Subject: Final Draft Master Plan for Bethesda-Chevy Chase

The Final Draft Master Plan for Bethesda-Chevy Chase prepared by the Montgomery County Planning Board and revised by the County Executive, is approved with the modifications listed below:

**P11**

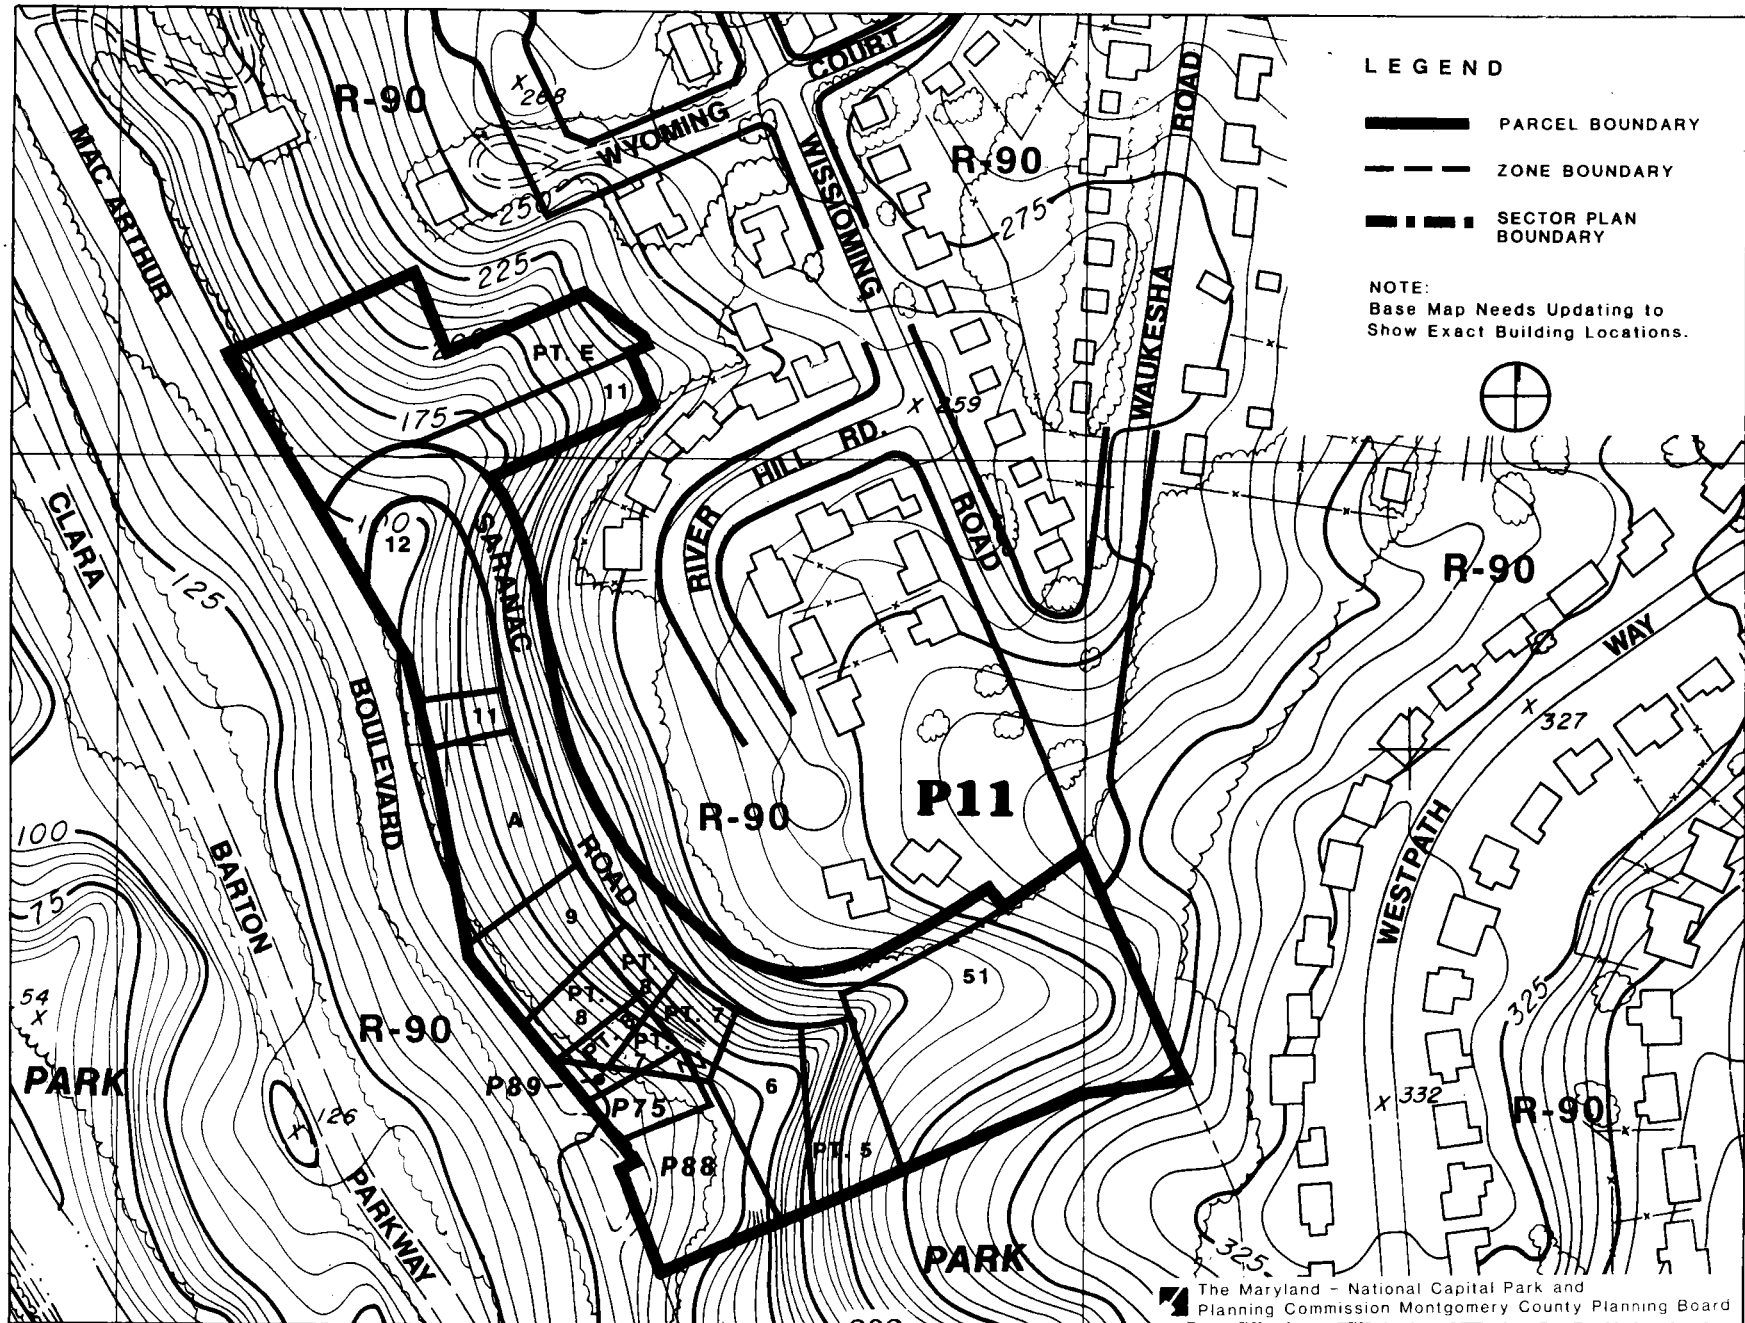
- Page 185 Delete all reference to P 11 (Springfield Drive), P 12 (Beech Avenue), and P-13 (Ewing Drive).

# GEICO'S ILLUSTRATIVE SITE PLAN

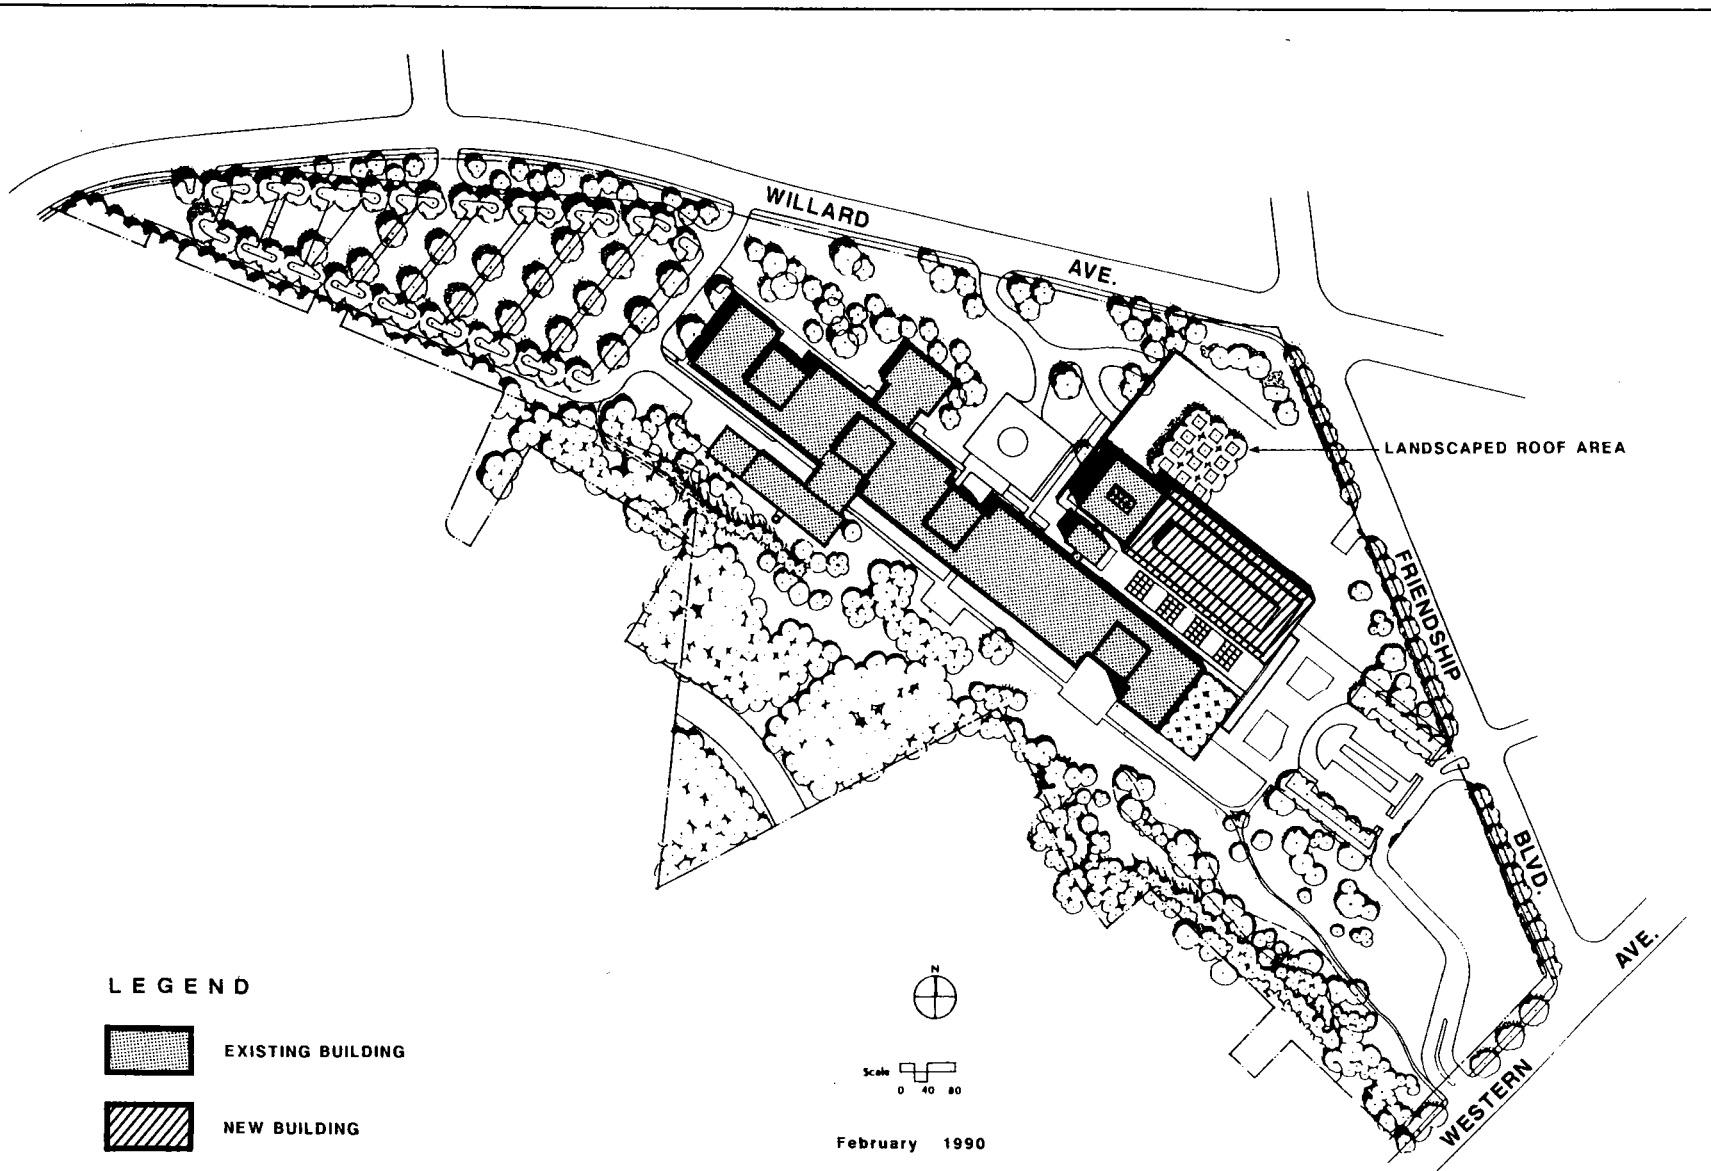
This Master Plan recommends expansion of the C-0 zoned area to allow 220,000 square feet of additional office space on the GEICO property. Underground parking will serve the new development and replace the existing Western Avenue surface parking lot. (See Figure 9.)

2. Any rezoning to C-0 should be limited in land area to permit the development of 220,000 square feet and to require Site Plan Review based upon the floor area ratio requirements of the Zoning Ordinance. (See Figure 9.)
